**AE 4100 Front panel PCB inner side
Modification for 40/40 Channels**

**This drawing is valid only for AE 4100
(with Channel display only)**

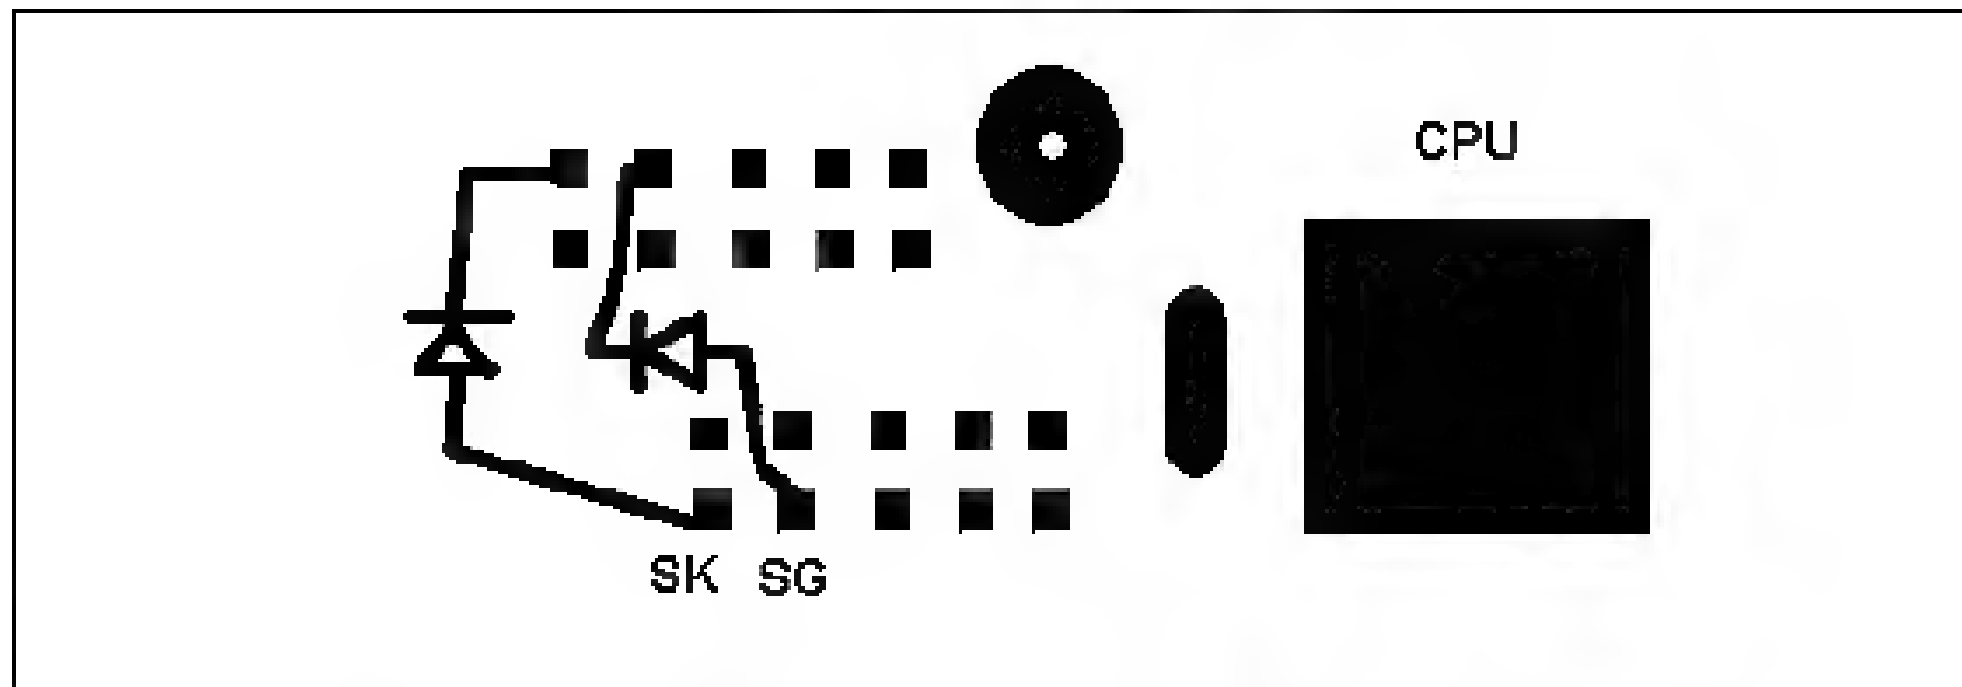
Trimmer Crystal

Additional Diodes (2 x 1 N 4148) for 40 CH AM+FM
